31/7-99F 9816 Capitol View Ave Capitol View Park HD

## HISTORIC PRESERVATION COMMISSION STAFF REPORT

Address: 9816 Capitol View Avenue, Silver Spring Meeting Date: 07/14/99

PROPOSAL: New Construction (Four houses, driveways, sidewalks, retaining wall, garages).

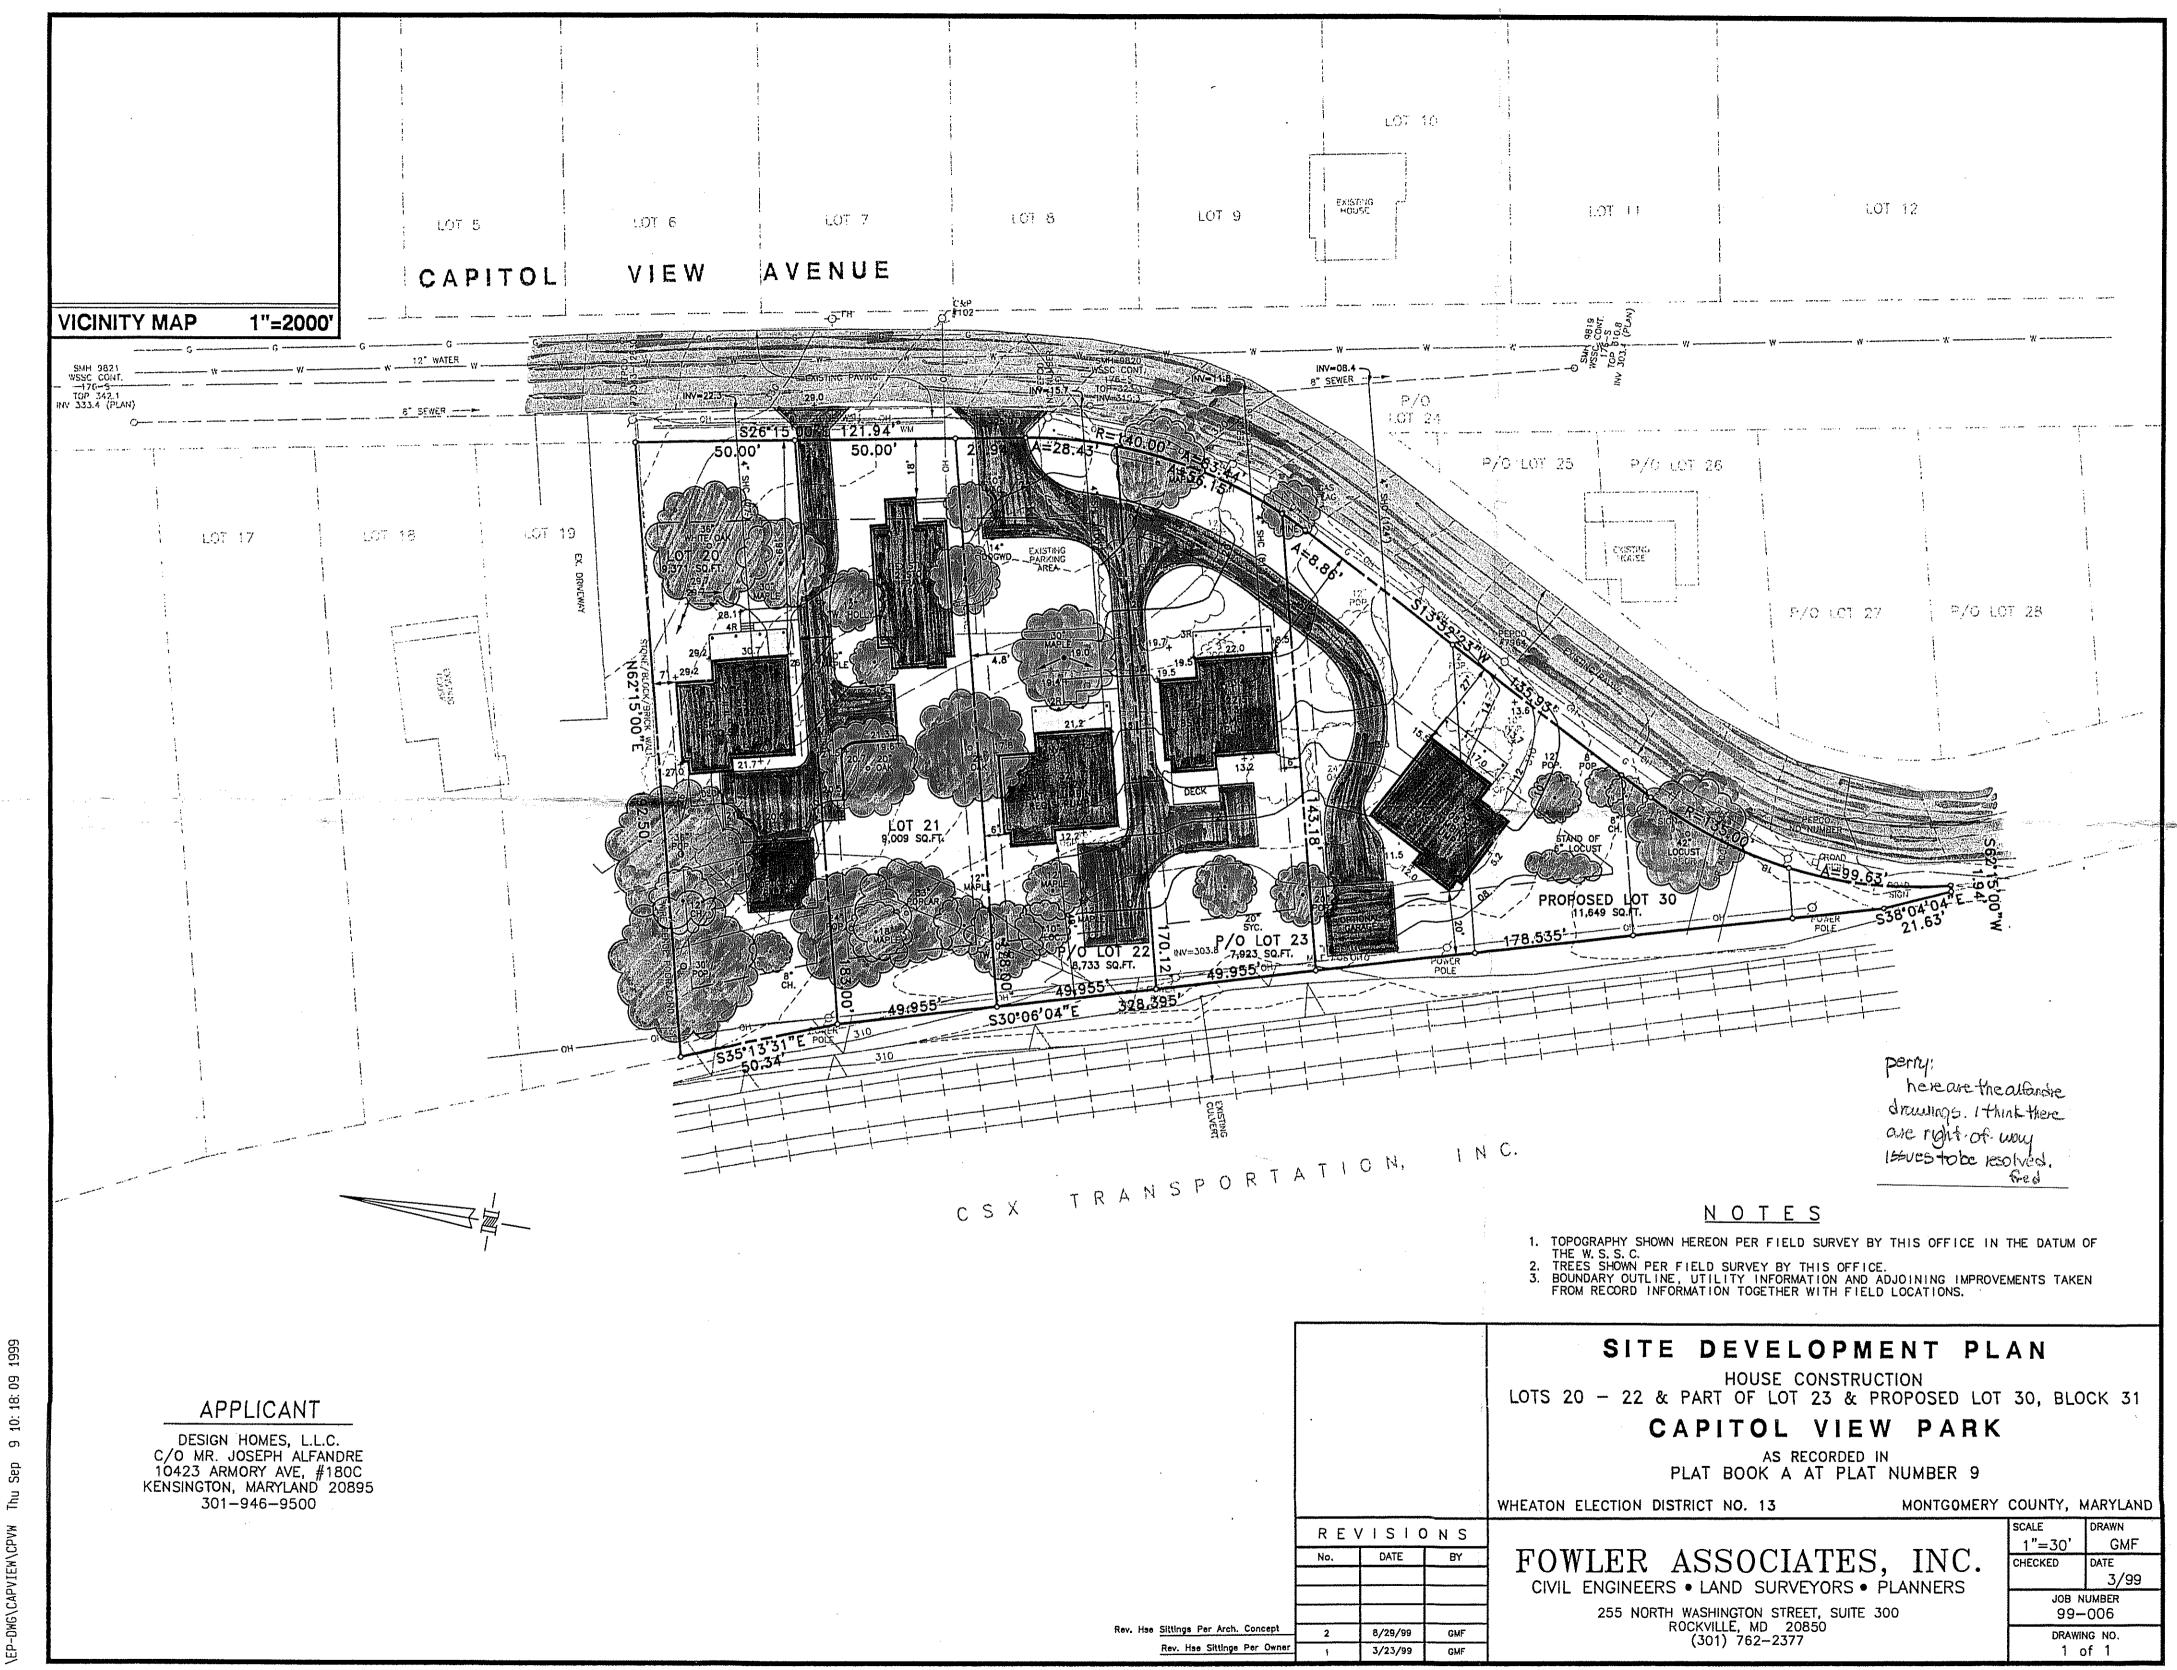
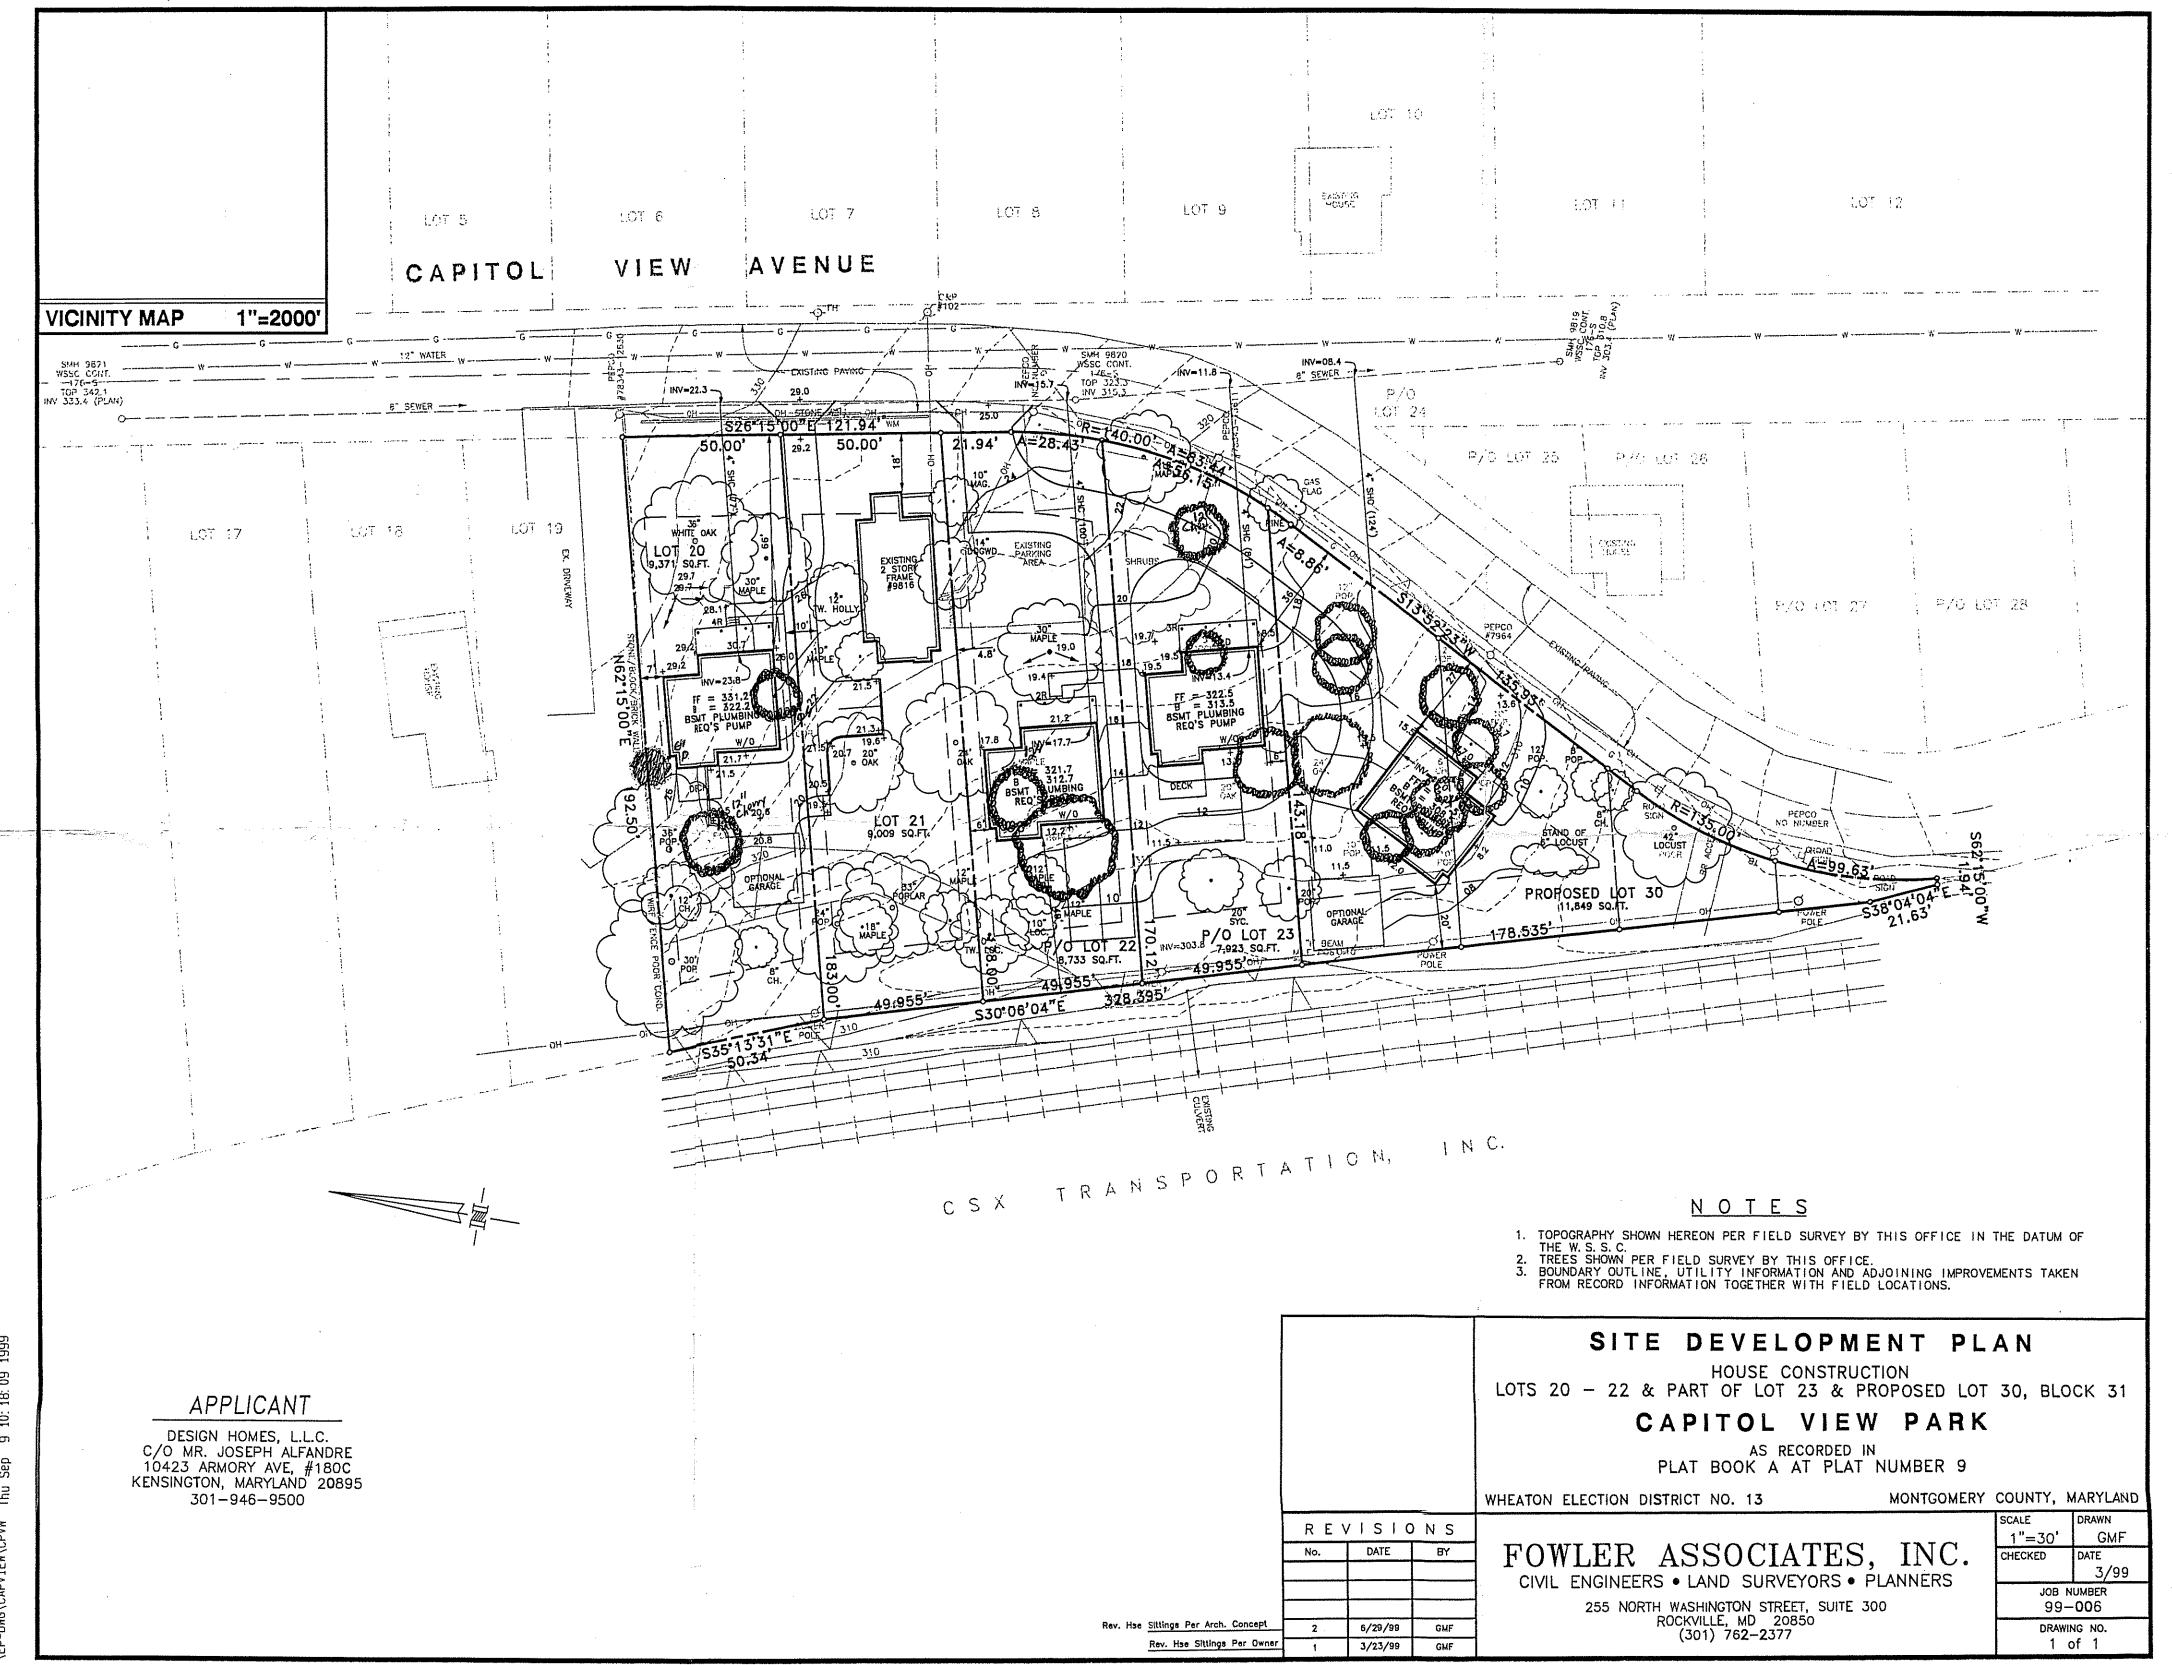
- E. Tree removal should be kept to a minimum.
  - 1. Although it is not apparent that the loss of the 24" oak between Lot 21 and Lot 22 can be avoided, staff would point out that this oak is one of the primary trees on the site and further study should be done to determine if the house placement can be modified to save it.

- 1. A tree protection plan, including stress reduction measures, is developed and provided to staff concurrently with a final grading and erosion control (retaining wall) plan.
- 2. The optional garages be deleted.
- 3. A modified paving plan be provided to include 9 foot roadways, a front hedgerow, deletion of paved parallel and visitor parking, and driveways to the optional garages.
- 4. Removal of the 24" oak on Lot 21 and the grove on Lot 30 be investigated further, with final resolution made at staff level.
- 5. The sidewalks be constructed of spaced paving stones rather than laid brick.
- 6. The designs for the signage, entry, and front fence be submitted to staff for approval.

L.A.P. Counter-proposal 9816 Capitol View Ave. MINIST PLANTO MINIST CONTEXT 58' 190 CAPITOL VIEW AVE. MT. PLEASAN AVE. 80' P/L 24 P/L 25 50 P/L 28 50° 50 50¹ P/L 27 TO COO COO NEW HOUSE HOUSE LOT 20 LOT 21 P/L 23 40112Z P/L 25 ELV P/L 24

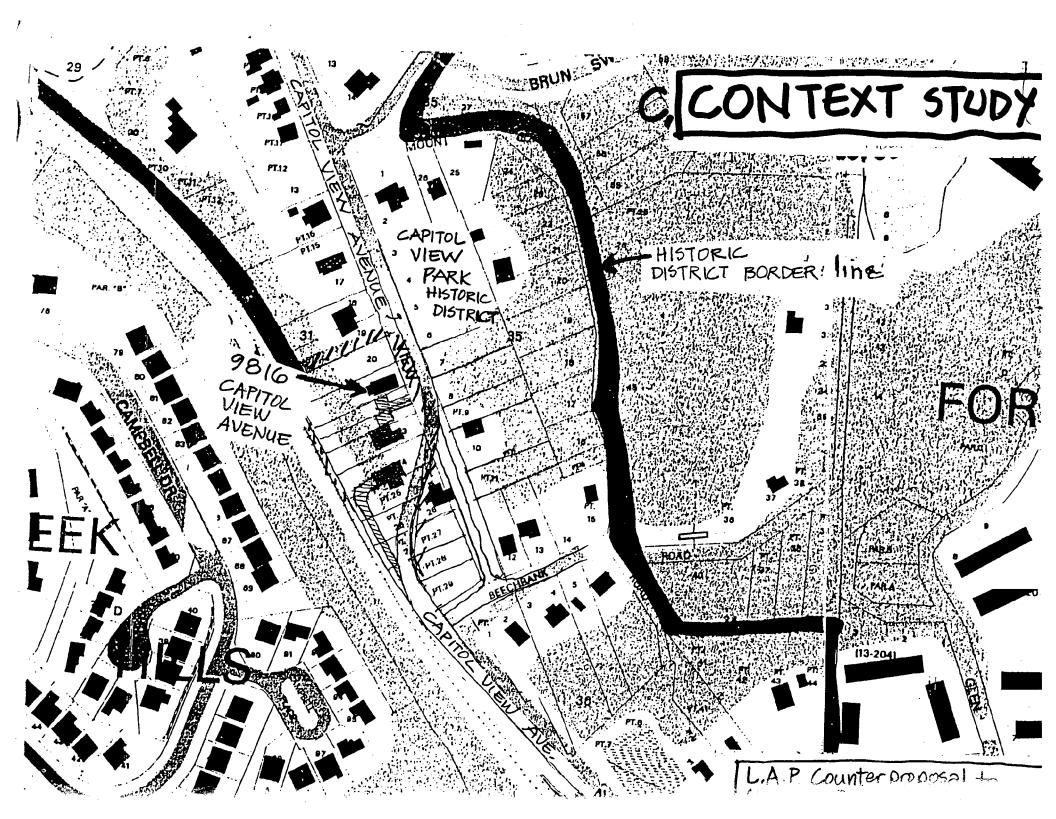
We appreciate the opportunity to express our views on this matter and hope that these concerns will be given due consideration.
